## Hempsted Lane, Gloucester [20/00315/OUT]

Project:	CRM.1132.021.HY.R.002.A - Outline Drainage Strategy
For:	Gladman Developments Ltd
Status:	Issued
Date:	11 <sup>th</sup> August 2022
Author:	Daniel Alstead BSc [Hons], MSc, MCIWEM, C.WEM - Associate Director
Approver:	Matt Travis BSc [Hons], MSc, MCIWEM, C.WEM, CEnv, CSci - Company Director

## Hempsted Lane, Gloucester, GL2 5DB - LLFA Response Letter

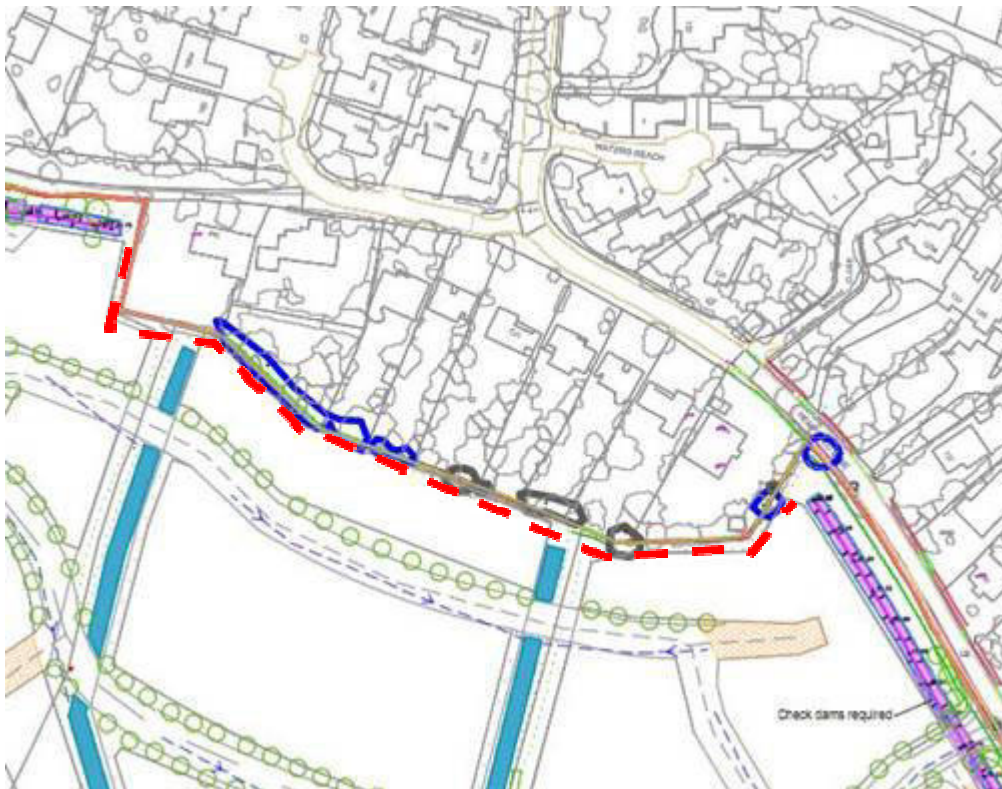
My only comment on flood risk from other sources is that due consideration will need to be given to surface runoff arriving at the development site from the uphill areas to the north. Due to the sloping site and the clay soils this could be significant. We would expect to see an intercept ditch/swale at detailed design stage.

An intercept swale (with check dams) has been provided along part of the northern boundary – in purple below (where a gravity connection around the east / west of the site is possible). This leaves a section in the centre (shown below in red) which remains unprotected. Can an intercept swale / ditch please be added here. It could be connected into the proposed swales (blue lines), with an appropriate allowance for the attenuation provision. I appreciate that the highway will intercept overland flows from north of the highway, but we have had similar (sloping, clay) sites before where problematic runoff has been generated over a relatively small area.

Revised drainage drawings are included in Attachment 2. A swale has been positioned along the northern boundary, which then conveys flows to the central swales, which direct flows into the onsite attenuation basin.

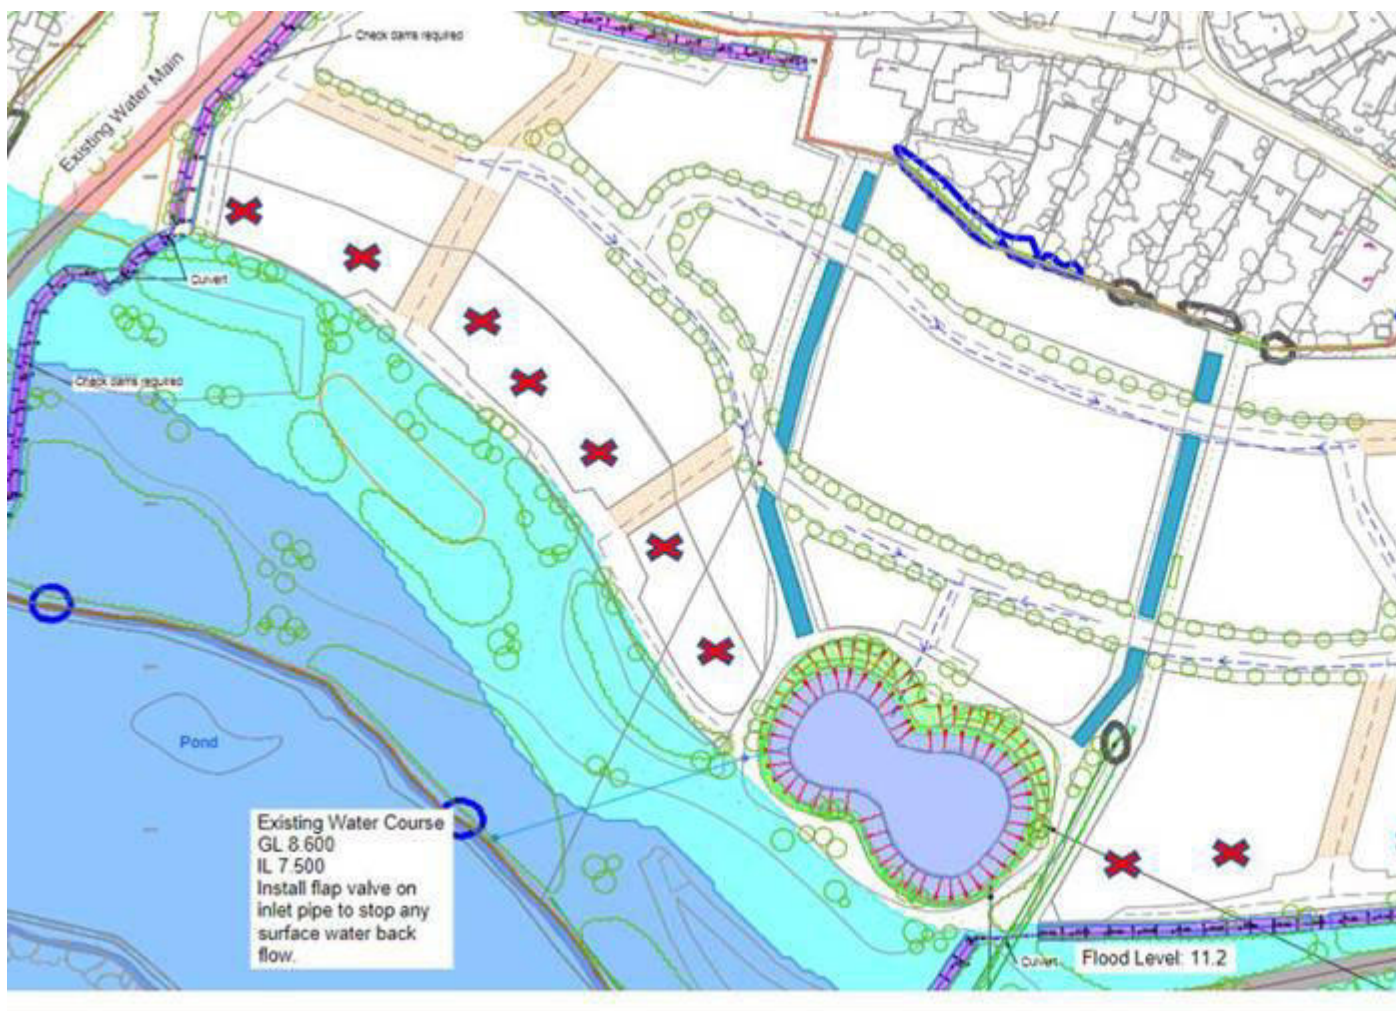
Where runoff volumes are being calculated for a defined area of impermeable surfacing (as they are here), we would normally expect the cv value to be 0.95. Here, Cv values of 0.75 / 0.84 (summer / winter) have been used. Clarification is sought.

The attenuation volume calculations don't make any allowance for the capture of runoff from permeable area. Presumably some permeable area (that uphill of new drainage provision) will contribute surface water runoff to the new drainage network. An allowance is needed here. Sometimes we see 20% of contributing permeable added at 100% runoff.

A 20% allowance for the permeable area has been added to the revised drainage calculations, alongside 20% allowance for the 0.604ha private garden area to the north. Revised runoff and attenuation calculations are included in Attachment 3, which are based on an impermeable area of 4.22ha.

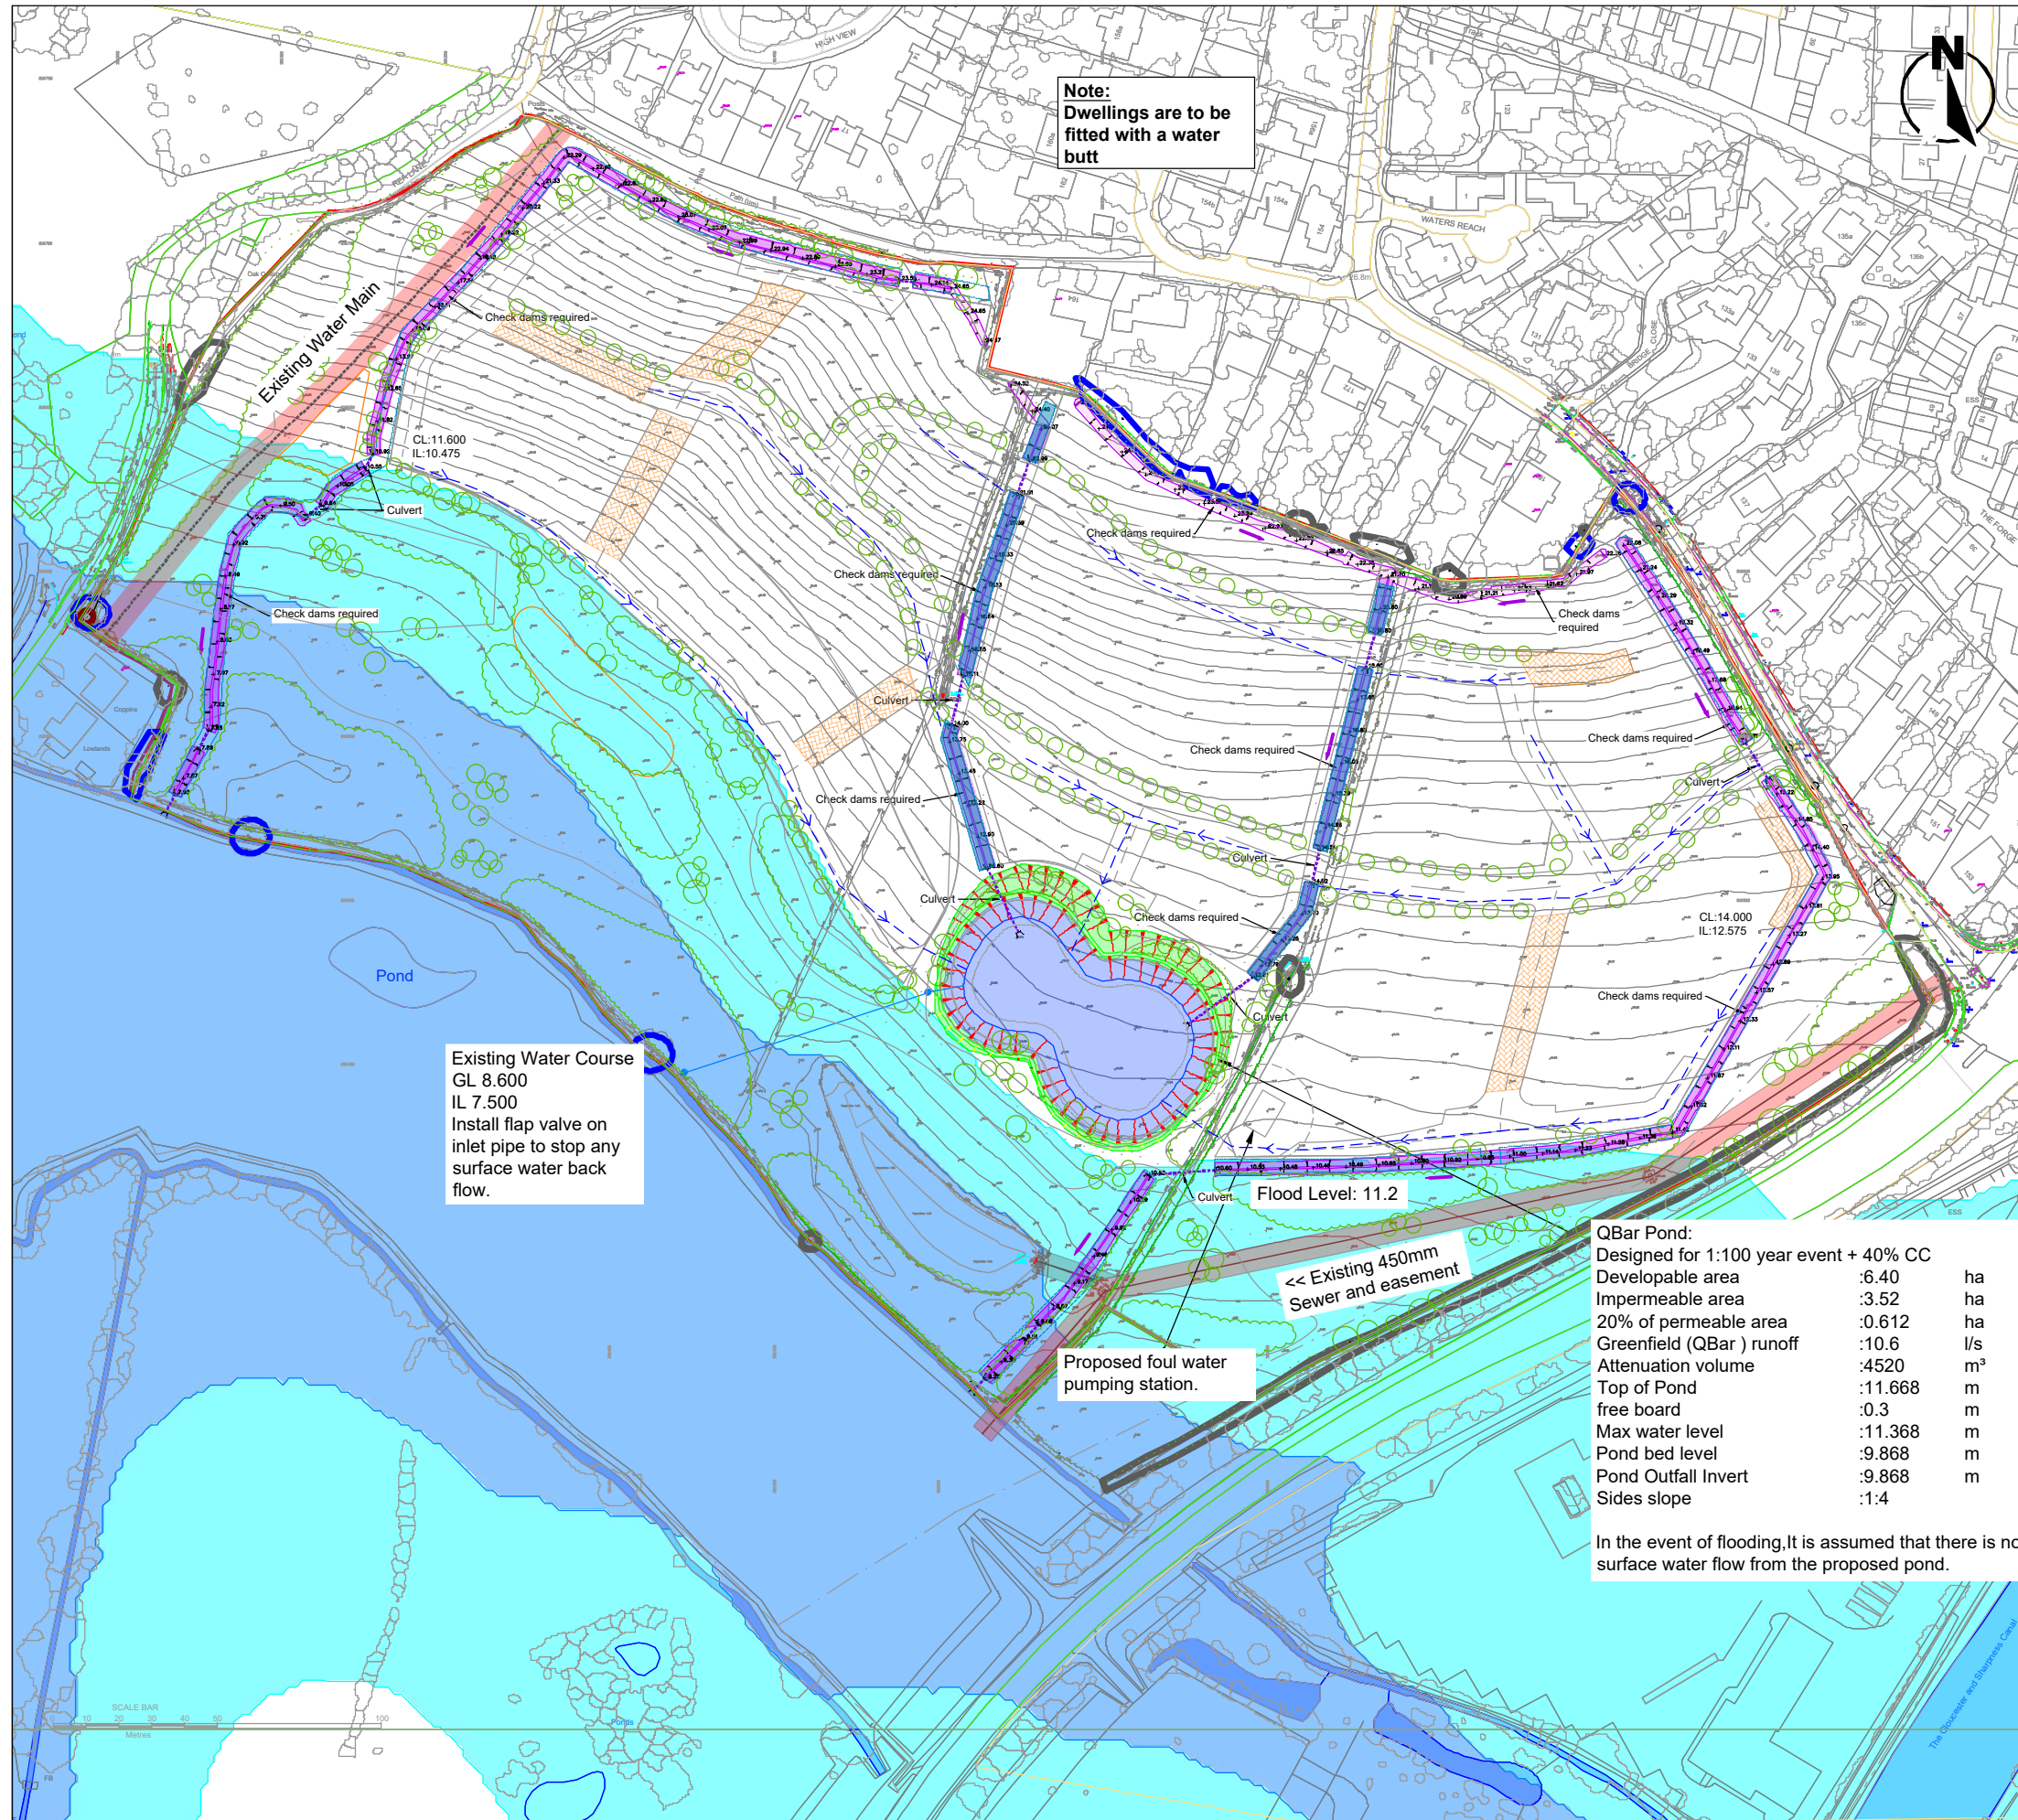
These on-site drains are being converted into swales. ok

These on-site watercourses currently have culverted sections due to previous infilling by the landowner. We require that these culverted sections are removed and the watercourses / ditches reinstated. This is in line with sections 3.5.39 and 3.5.40 of the City Plan. Currently, if the culverted sections block, the repercussions are minimal as flood would simply flow across the fields to the Hempsted Brook. However, in event that the site is developed, blockages could have more serious consequences.

These on-site drains / ditches are being converted into swales. ok

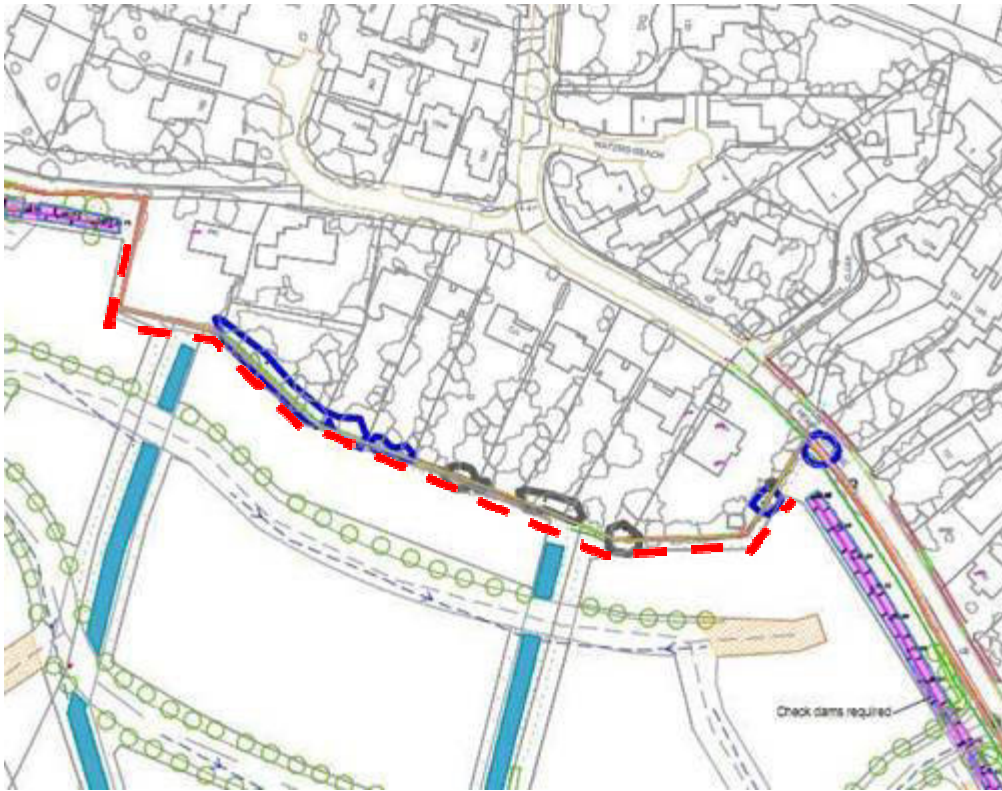
My only comment on flood risk from other sources is that due consideration will need to be given to surface runoff arriving at the development site from the uphill areas to the north. Due to the sloping site and the clay soils this could be significant. We would expect to see an intercept ditch/swale at detailed design stage.

An intercept swale (with check dams) has been provided along part of the northern boundary – in purple below (where a gravity connection around the east / west of the site is possible). This leaves a section in the centre (shown below in red) which remains unprotected. Can an intercept swale / ditch please be added here. It could be connected into the proposed swales (blue lines), with an appropriate allowance for the attenuation provision. I appreciate that the highway will intercept overland flows from north of the highway, but we have had similar (sloping, clay) sites before where problematic runoff has been generated over a relatively small area. Additional length of intercept swale added. Now ok

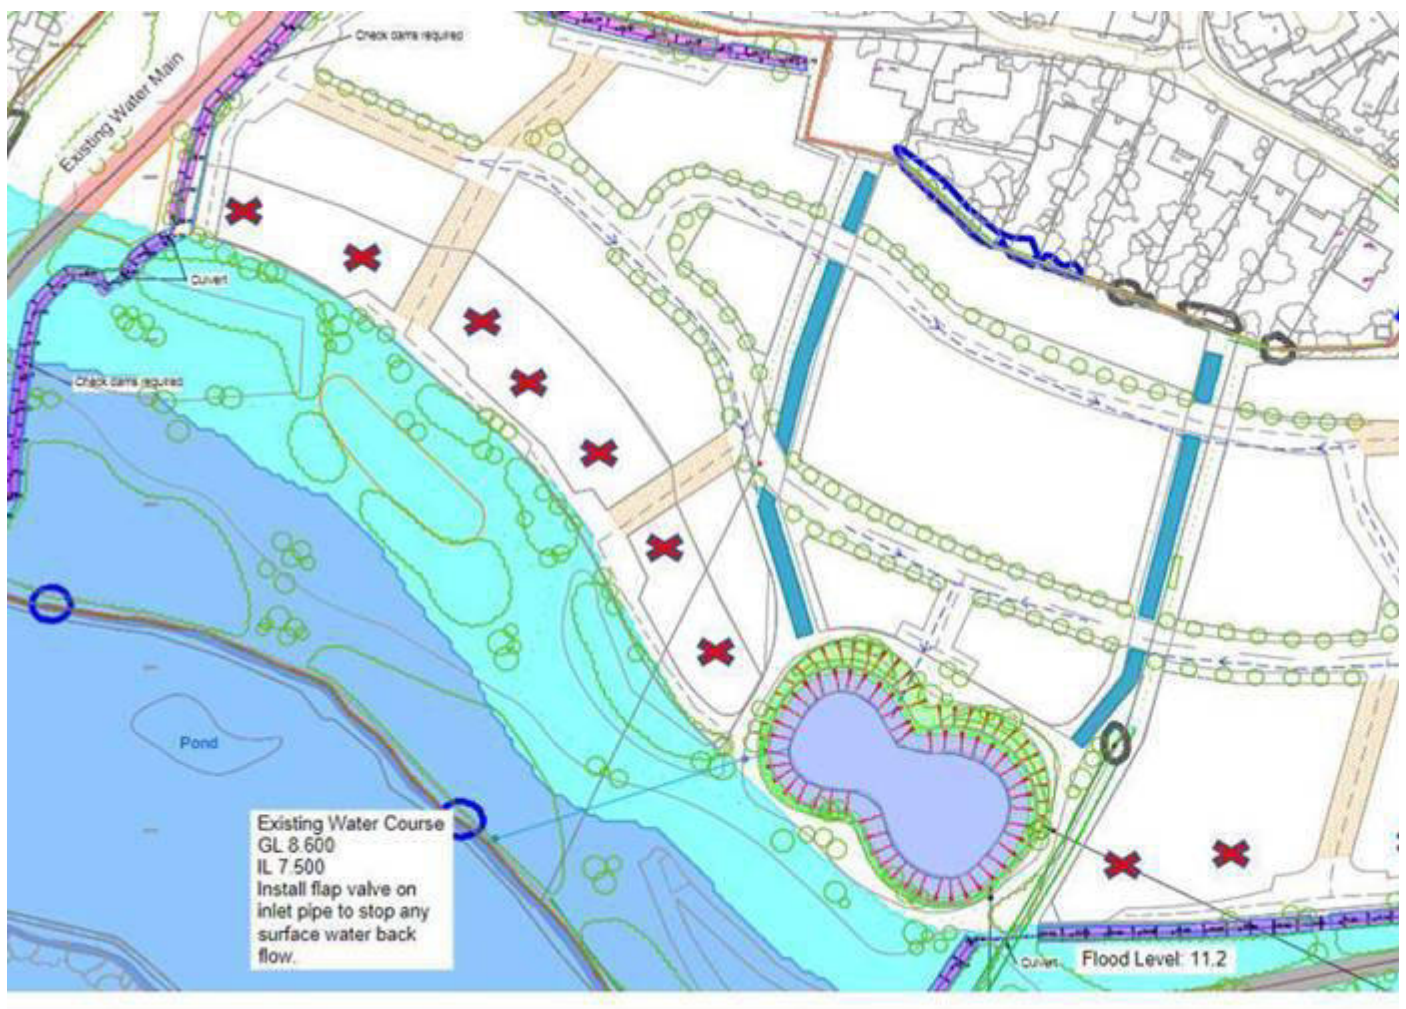
The runoff from the permeable areas has to go somewhere. It will either:

- 1) Be captured by the on-site drainage - in which case that area can be include in the QBar calculations, but the attenuation volume calculations will need to make allowance for the runoff.
- or
- 2) Not be captured by the on-site drainage – in which case that area should not be included in the QBar calculations.

Where runoff volumes are being calculated for a defined area of impermeable surfacing (as they are here), we would normally expect the cv value to be 0.95. Here, Cv values of 0.75 / 0.84 (summer / winter) have been used. Clarification is sought.

The attenuation volume calculations don't make any allowance for the capture of runoff from permeable area. Presumably some permeable area (that uphill of new drainage provision) will contribute surface water runoff to the new drainage network. An allowance is needed here. Sometimes we see 20% of contributing permeable added at 100% runoff. This has now been done. ok

#### Watercourses

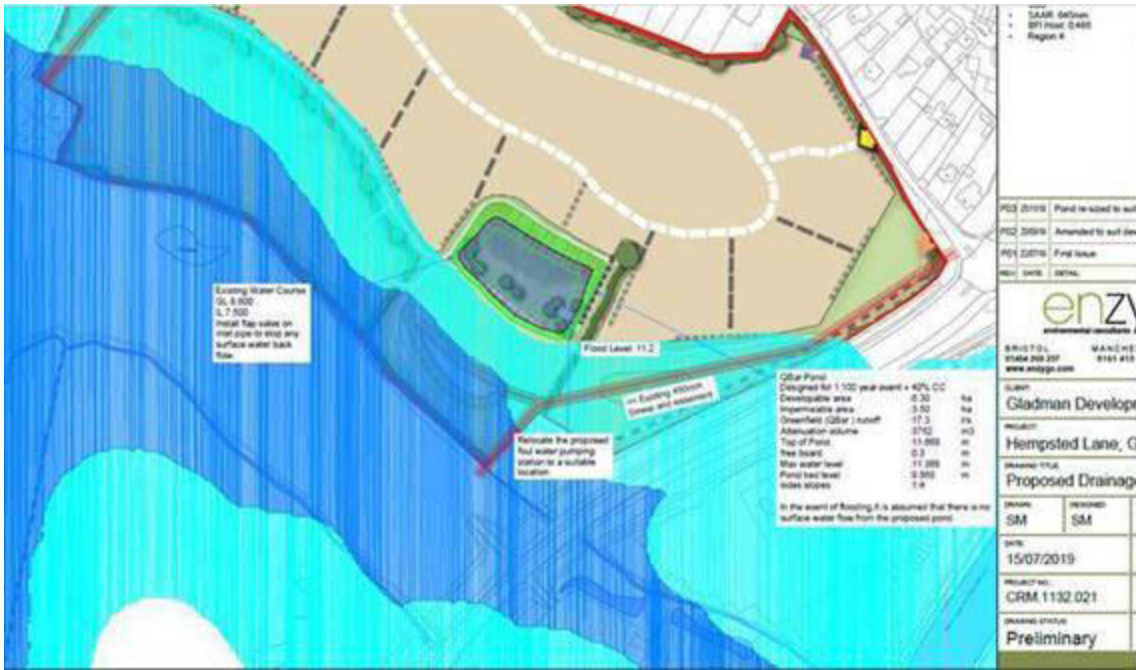
Gloucester City Council requires that an 8 m corridor be kept free of development to each side of watercourses (measured from top of bank). This is achieved for Hempsted Brook (Black Ditch) as there is no development in this area. The 4 m corridor (4 m to each side) proposed for the smaller on-site watercourses is considered acceptable here.

These on-site drains are being converted into swales. ok

These on-site watercourses currently have culverted sections due to previous infilling by the landowner. We require that these culverted sections are removed and the watercourses / ditches reinstated. This is in line with sections 3.5.39 and 3.5.40 of the City Plan. Currently, if the culverted sections block, the repercussions are minimal as flood would simply flow across the fields to the Hempsted Brook. However, in event that the site is developed, blockages could have more serious consequences.
